Proposal to amend document ECE/TRANS/WP.29/2017/53)

Draft General Guidelines for UN regulatory procedures and transitional provisions in UN Regulations

"Figure 1

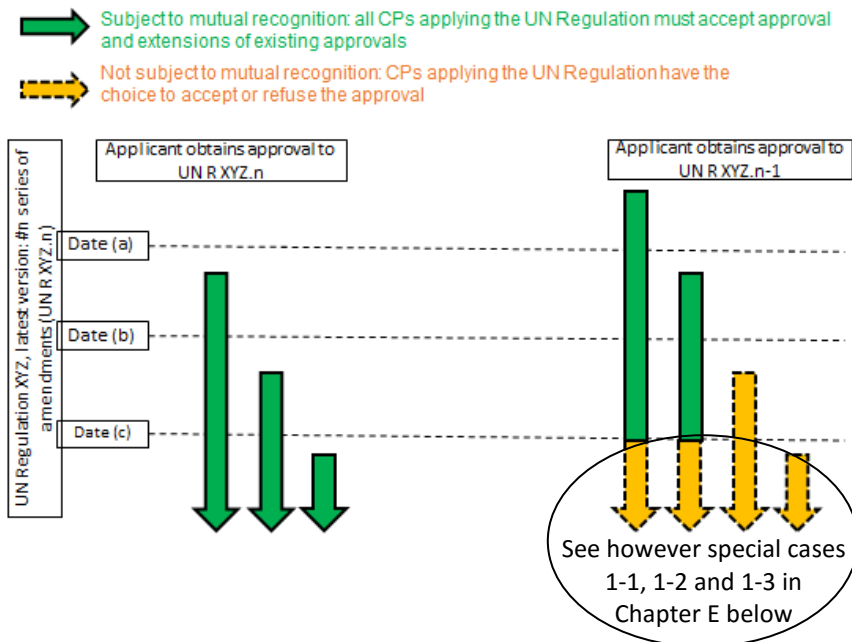
1. Paragraph 25. Figure 1 amend to read:

Illustration of a transitional period for a vehicle, or vehicle systems, covered by a UN Regulation and its amendments

Note: If (b) and (c) dates are not written in to the transitional provisions, they are regarded as identical to date (a).

Existing approvals remain valid, but Contracting Parties are not obliged to accept them as from date (c).
